IFB No. 17-15 Auburn High School Softball Field

RE: ADDENDUM NO. 2

ROCKFORD PUBLIC SCHOOLS
17-15 Auburn High School Softball Field

SHEET NUMBER:
3 of 13

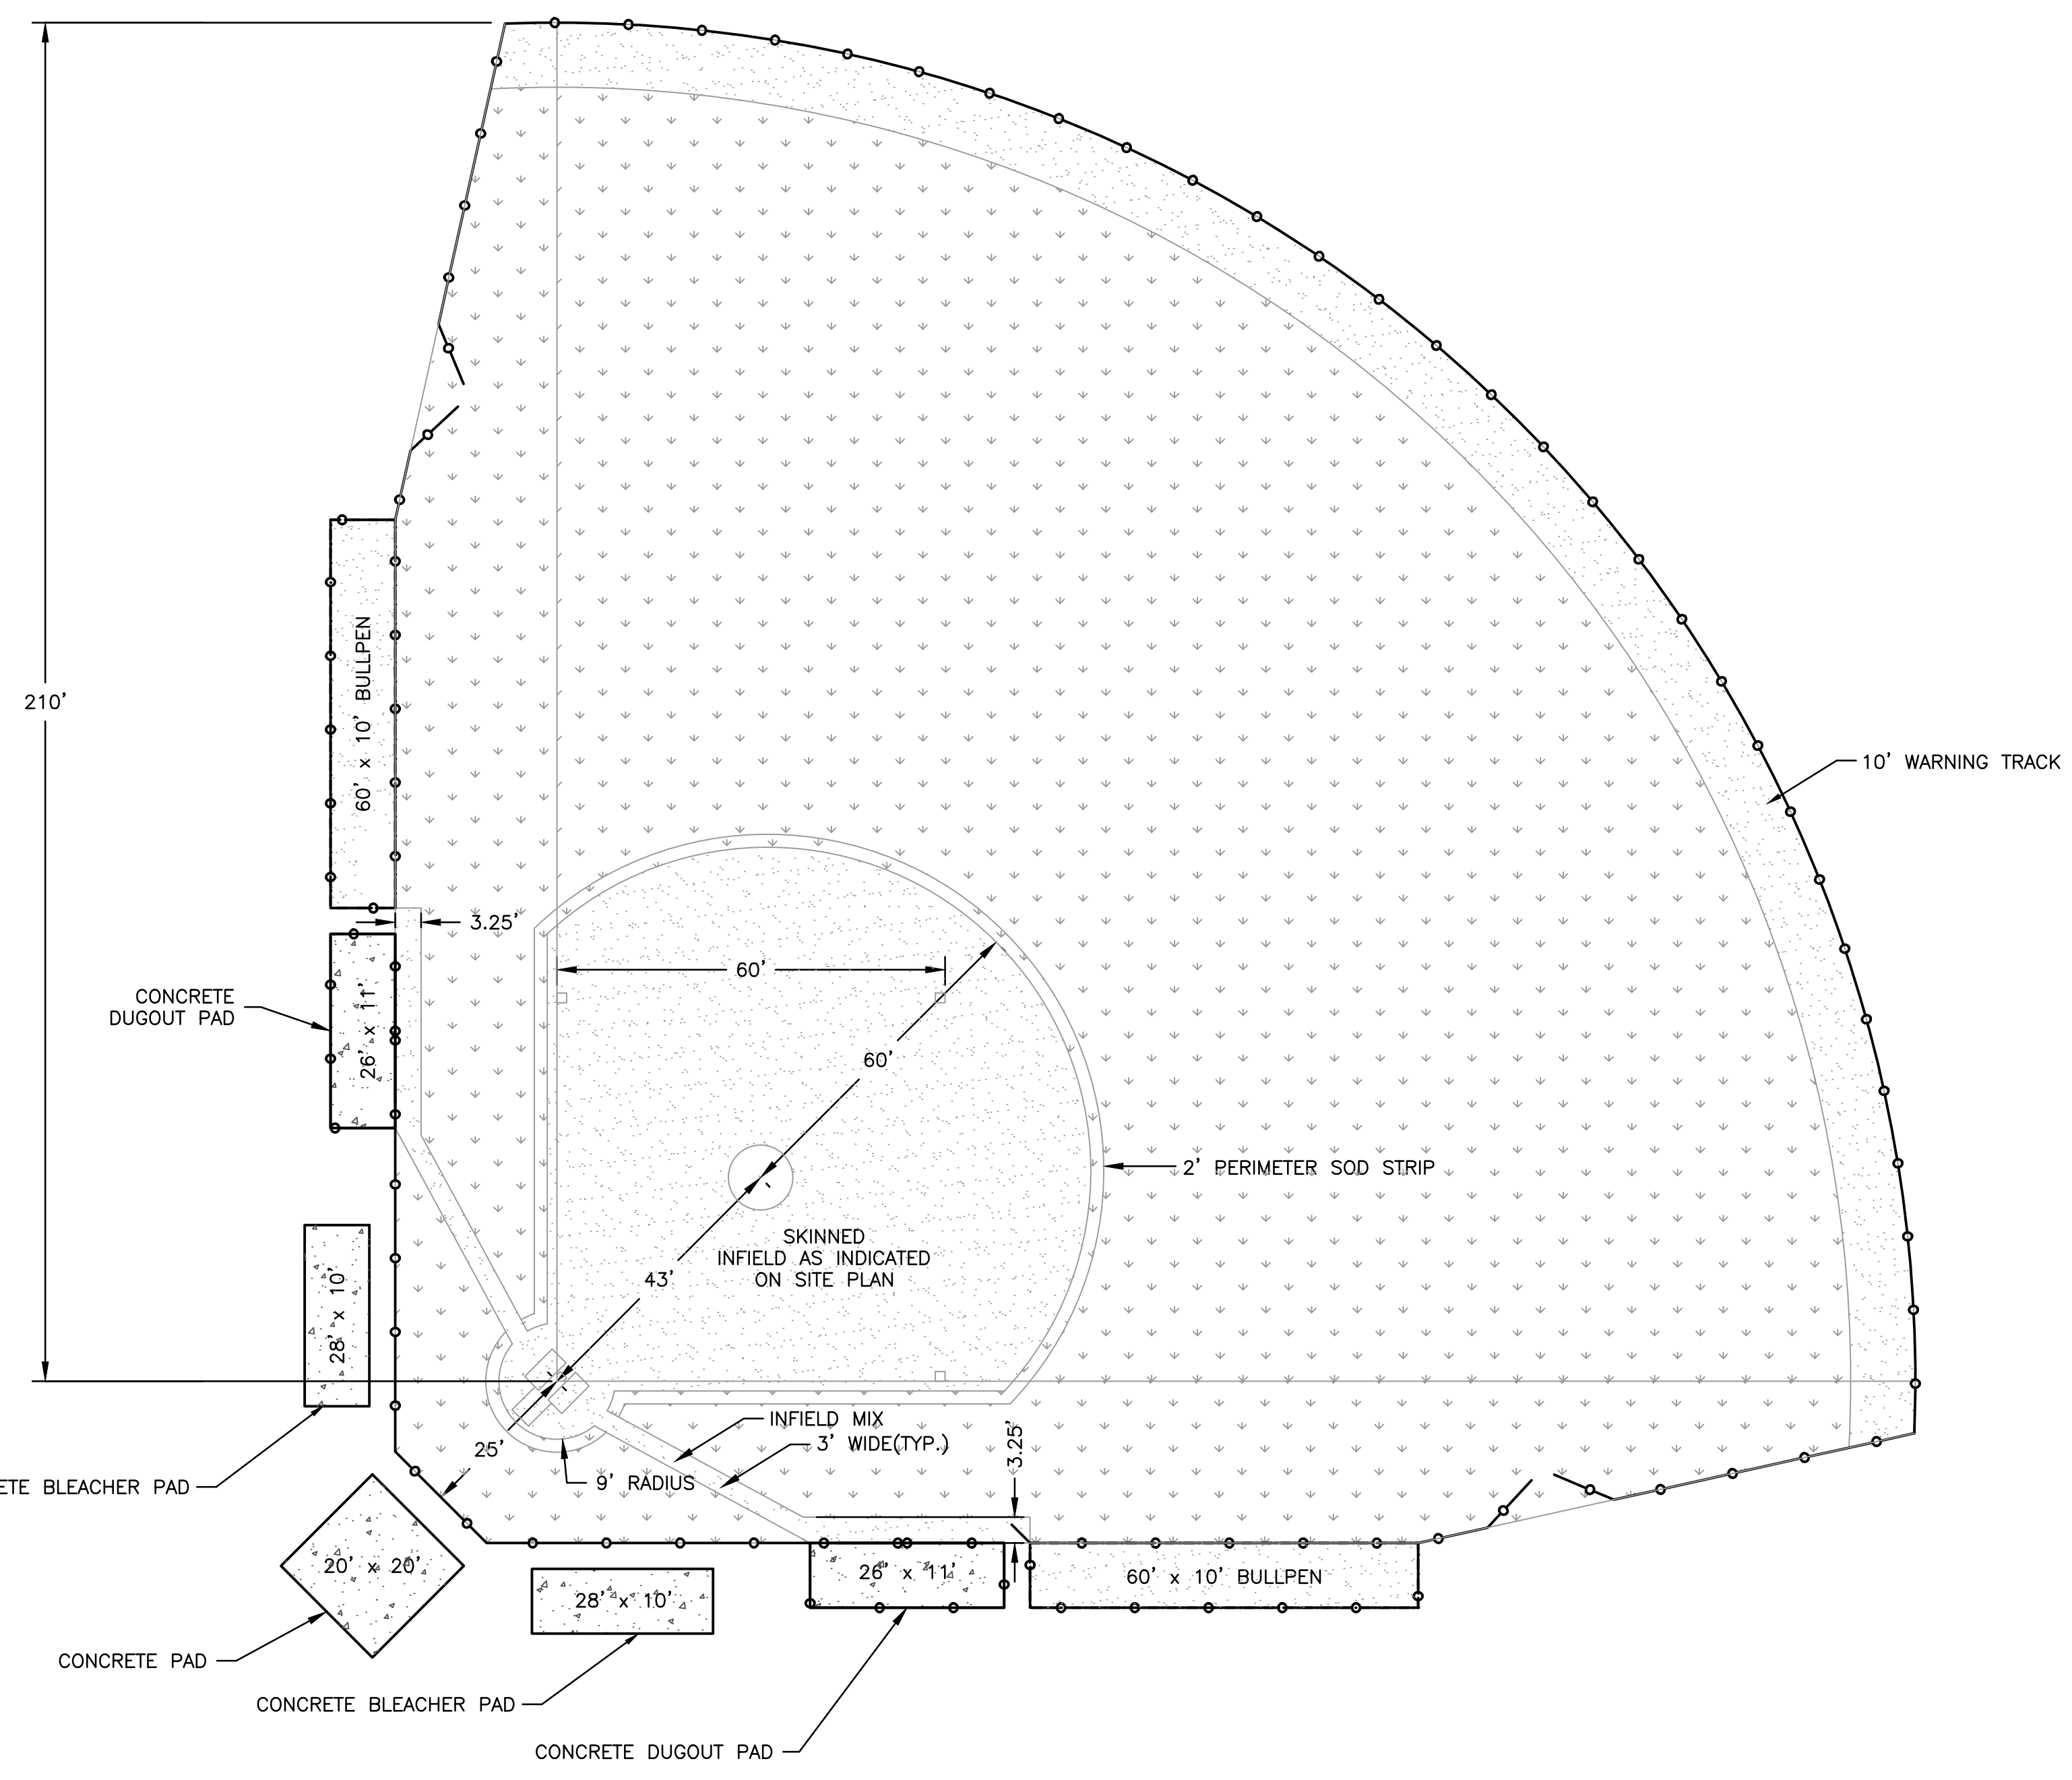
1. Sheet 3 of 13 – Updated Summary of Quantities.
2. Sheet 6 of 13 – Revised Concrete Dugout Pad size and revised IDOT specification for Infield Mix.
3. Sheet 10 of 13 – Additional note to allow dugout installation in Spring 2017 and revision of fence crown notes.
4. Sheet 11 of 13 – Backstop details have been revised to call for 4" O.D. posts. Post material list revised to call for 4" O.D. for double gate posts. Fence Crown material has been revised.
5. Sheet 13 of 13 – Revised Concrete Pad detail.

REVISIONS		
REV. NO.	DESCRIPTION	DATE
1	REVISED SUMMARY OF QUANTITIES	10/10/16

SHEET NUMBER:
6 of 13

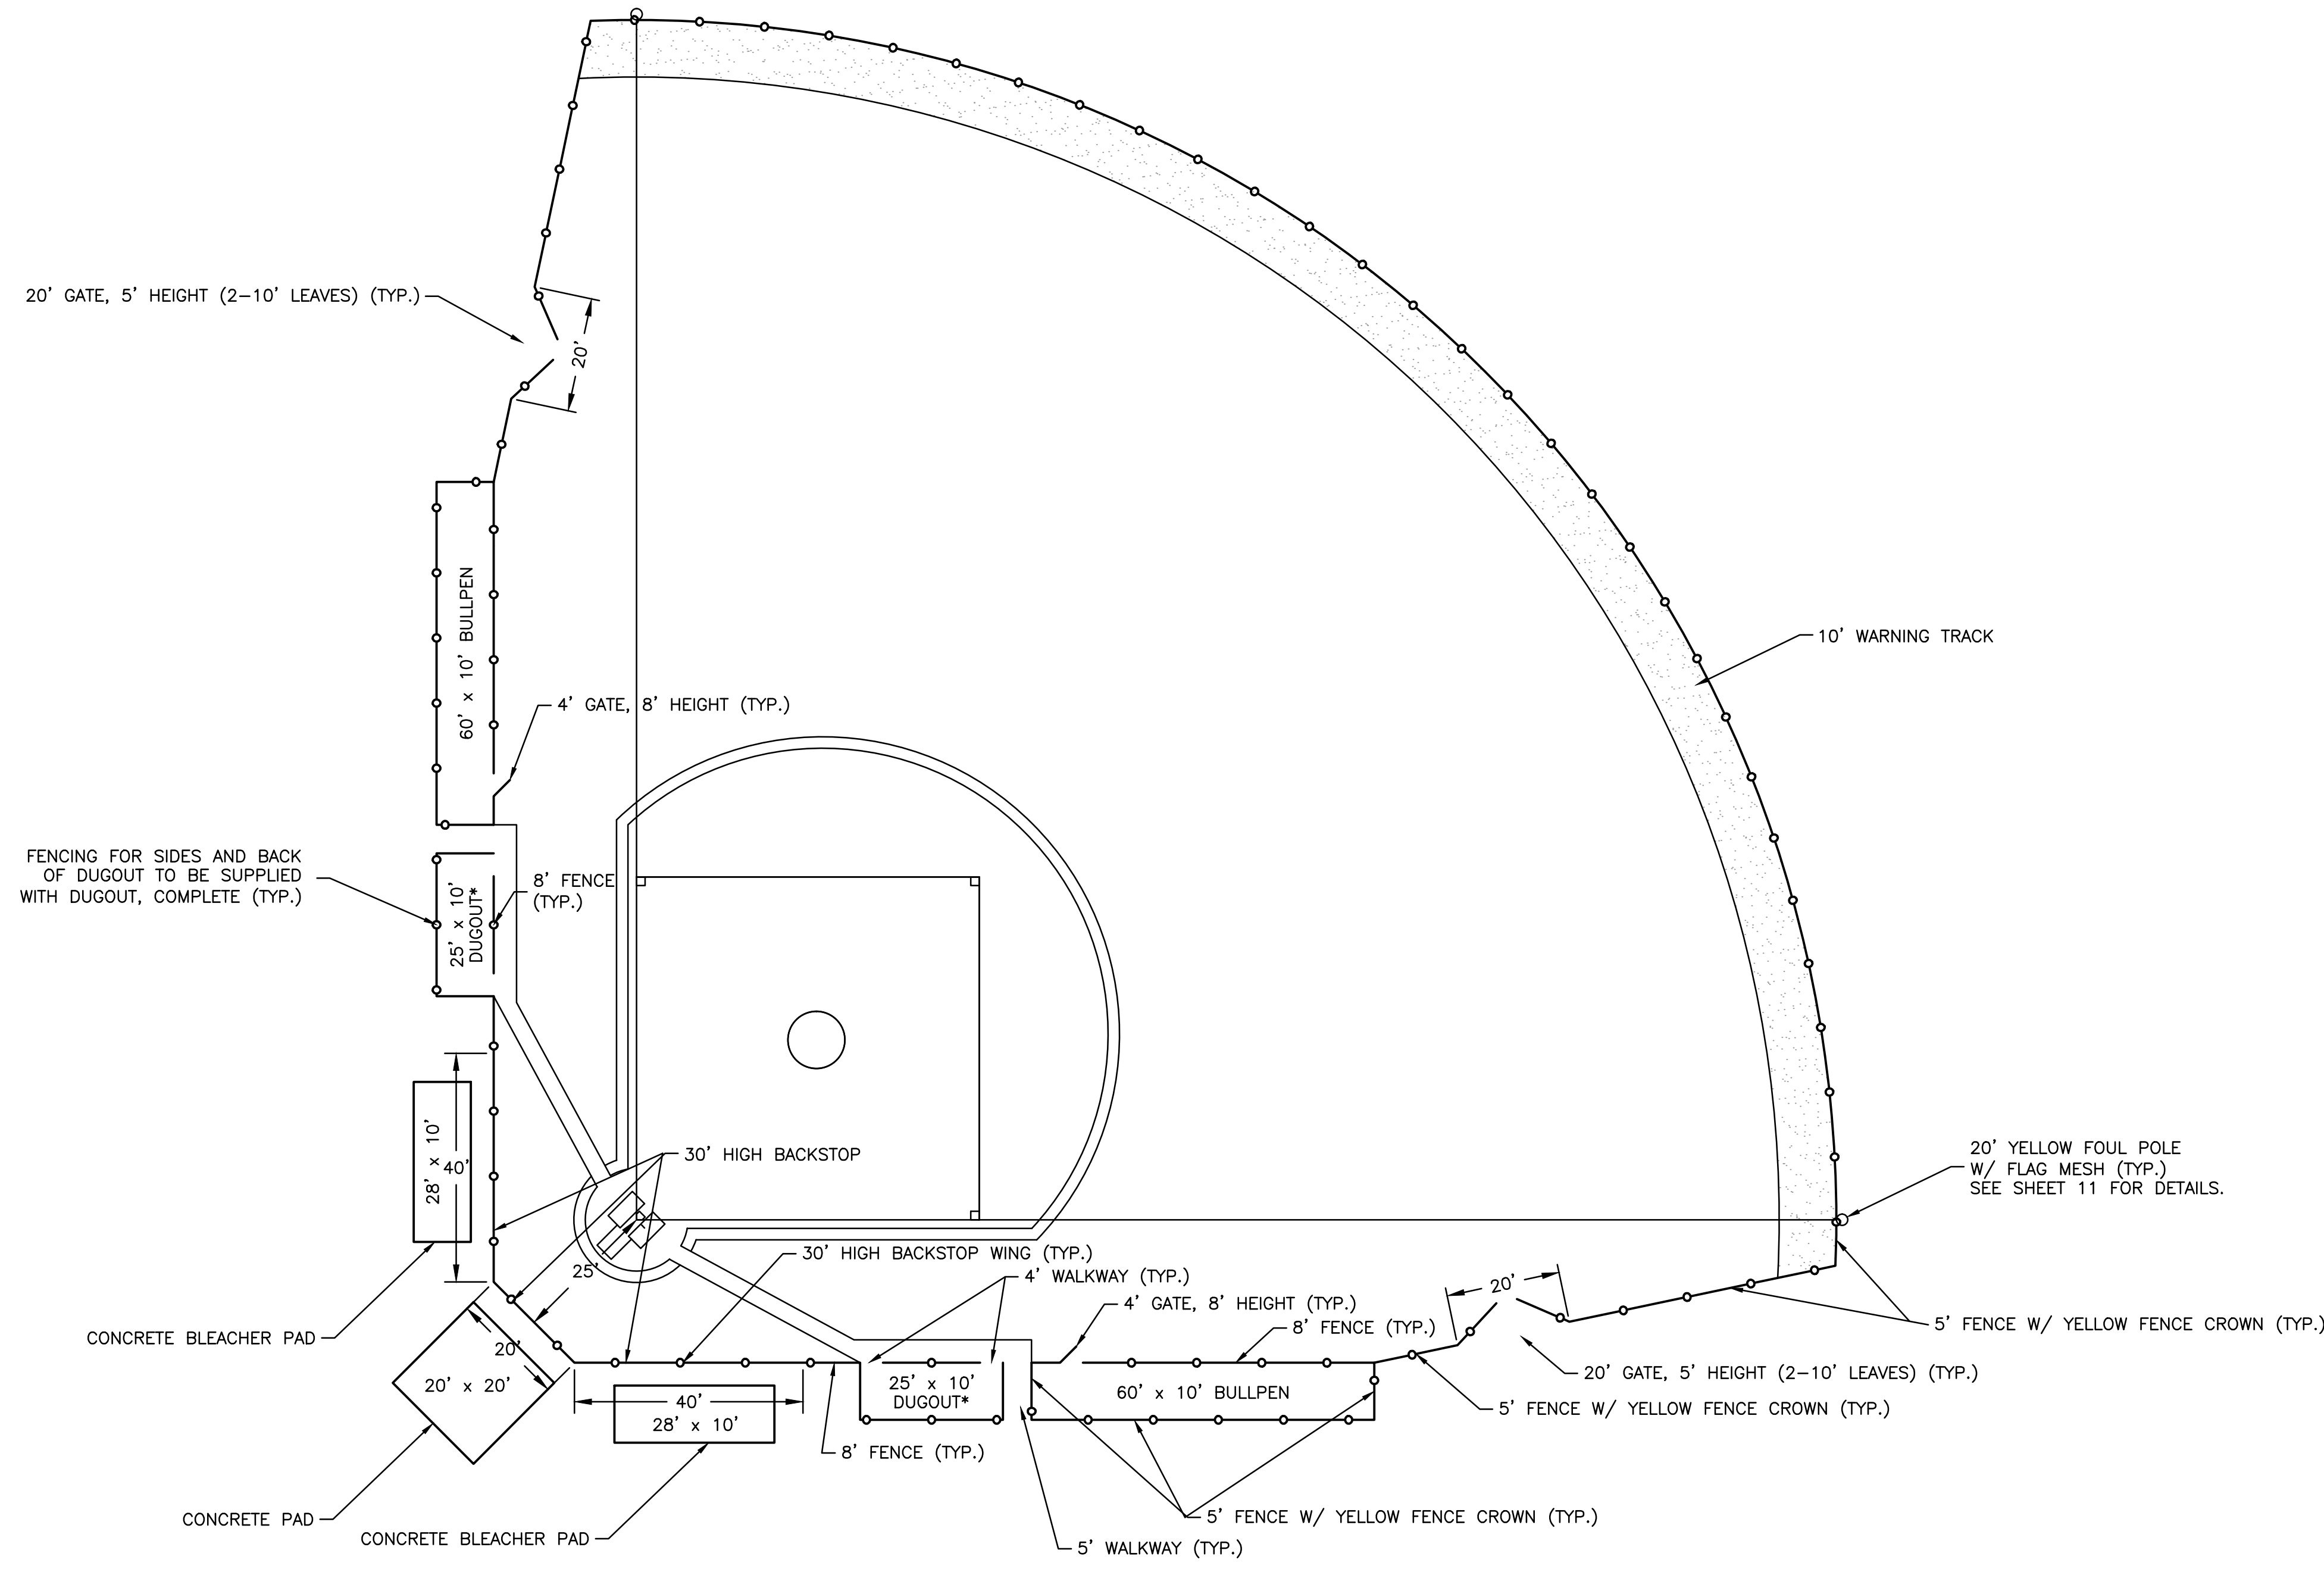
REVISIONS		
REV. NO.	DESCRIPTION	DATE
1	REVISION TO INFIELD MIX SPEC & DUGOUT PAD SIZE	10/10/16

INFIELD MIX – THE SKINNED AREAS SHALL CONSIST OF A 6" COMPACTED AG LIME (IDOT FA-8/FA-21 MATERIAL).

BACKSTOP DETAIL
N.T.S.

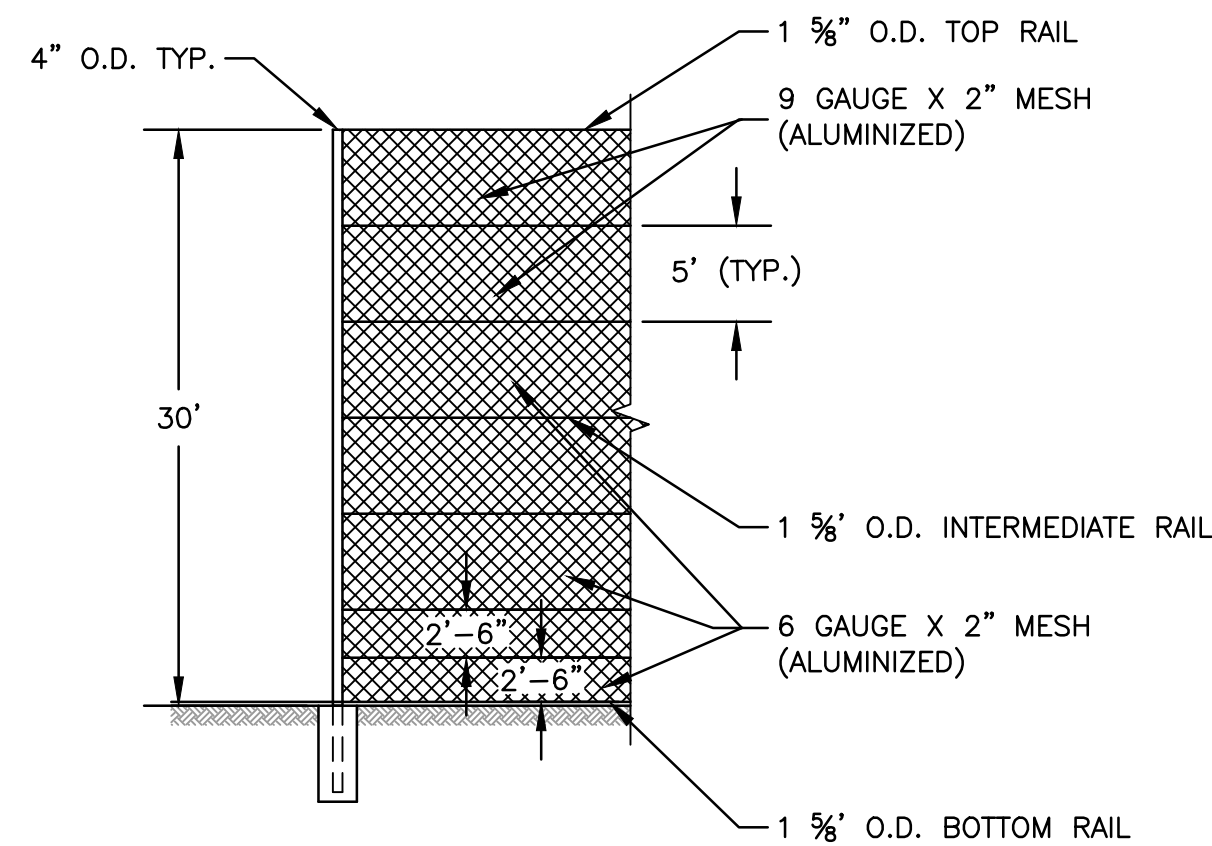
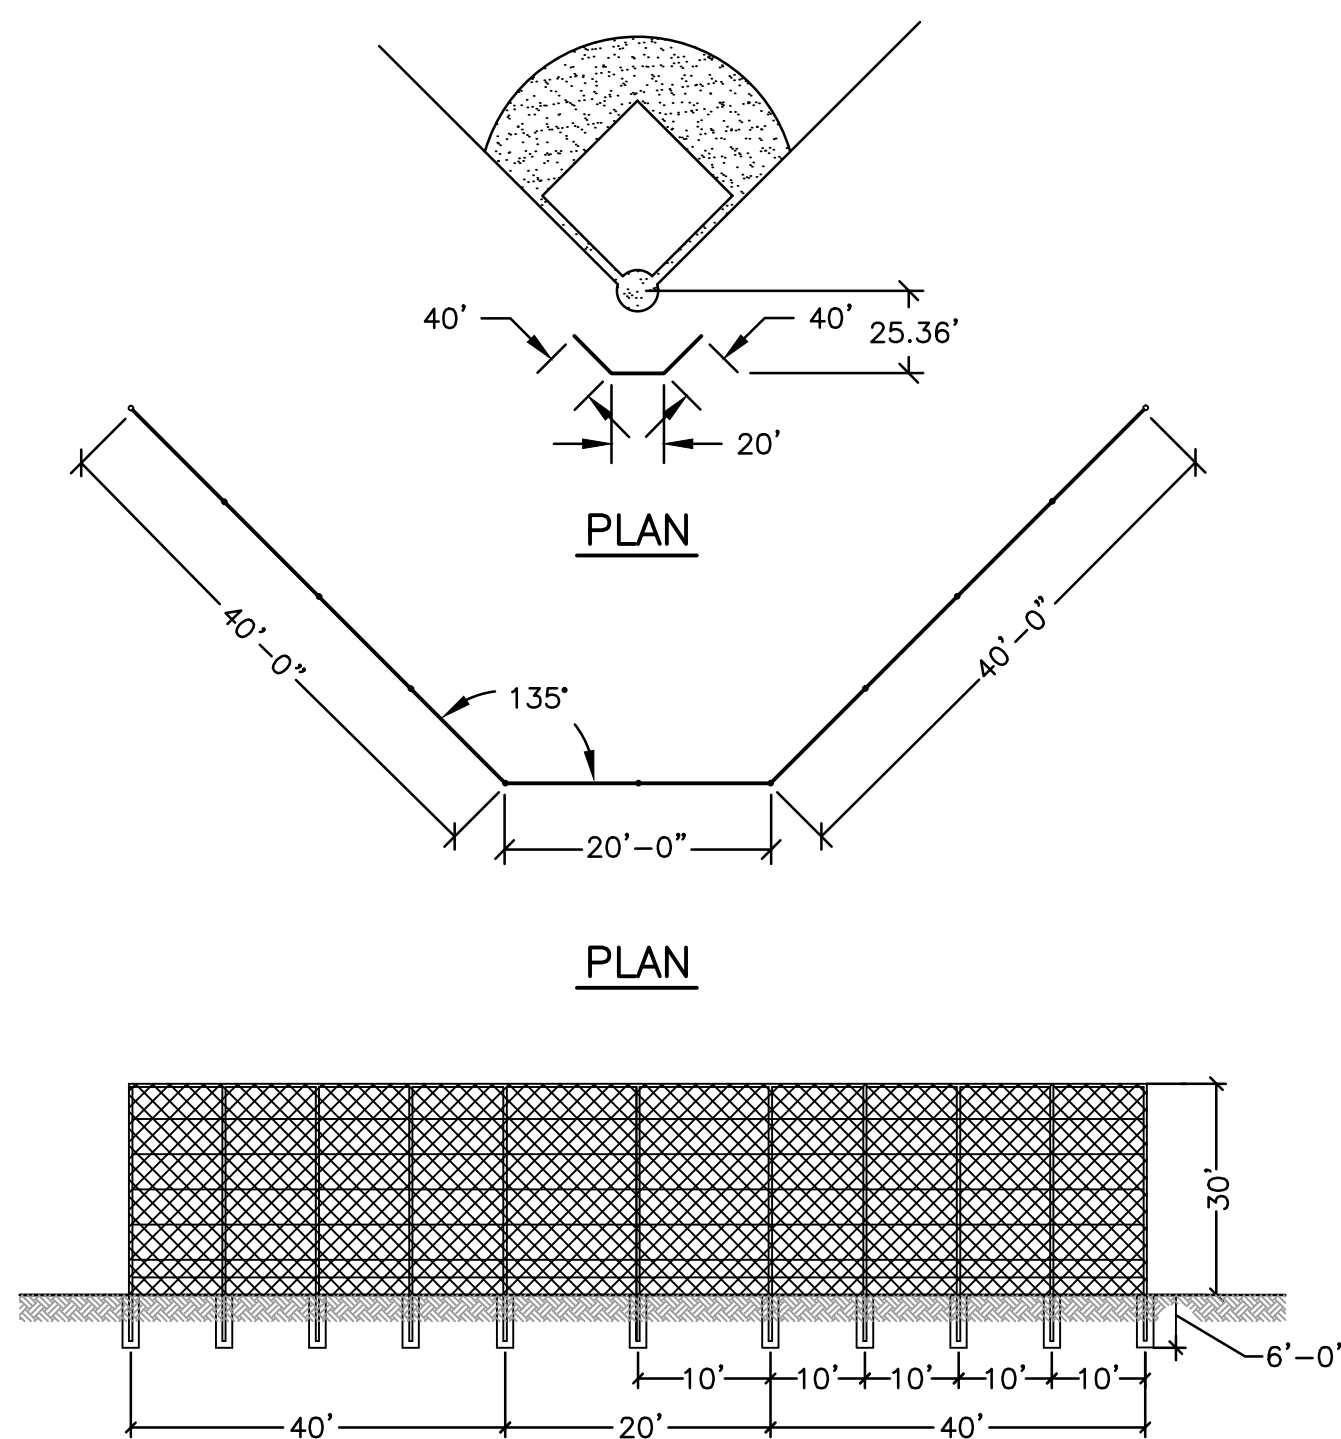
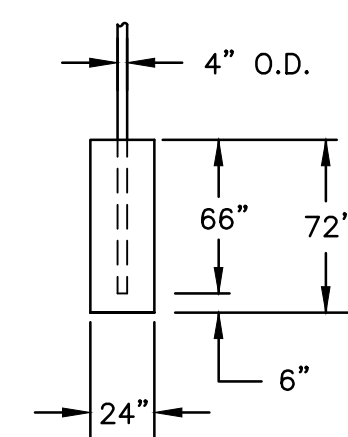
REVISIONS		
REV. NO.	DESCRIPTION	DATE
1	ADDITION OF SECOND FOUL POLE SUPPLIER, REVISED FENCE CROWN MATERIAL, & REVISED BACKSTOP DETAIL	10/10/16

CONCRETE PAD DETAIL
N.T.S.

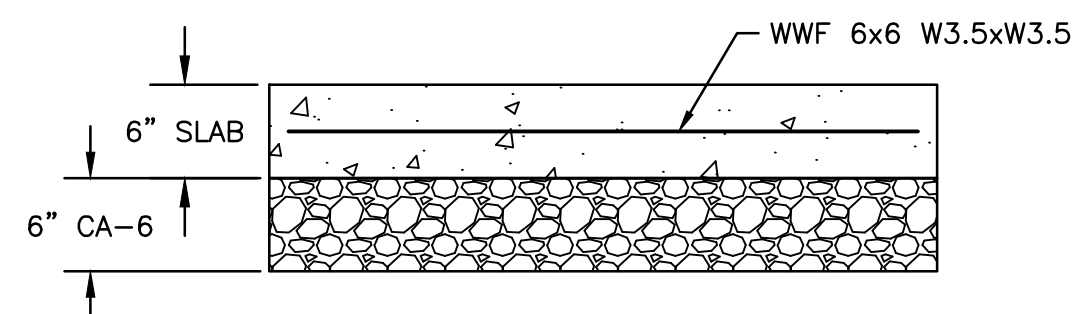
REVISIONS		
REV. NO.	DESCRIPTION	DATE
1	REVISED CONCRETE PAD DETAIL	10/10/16

NOTE: AGGREGATE BASE SHALL BE CONSIDERED INCIDENTAL TO CONTRACT UNIT PRICE FOR CONCRETE PADS.
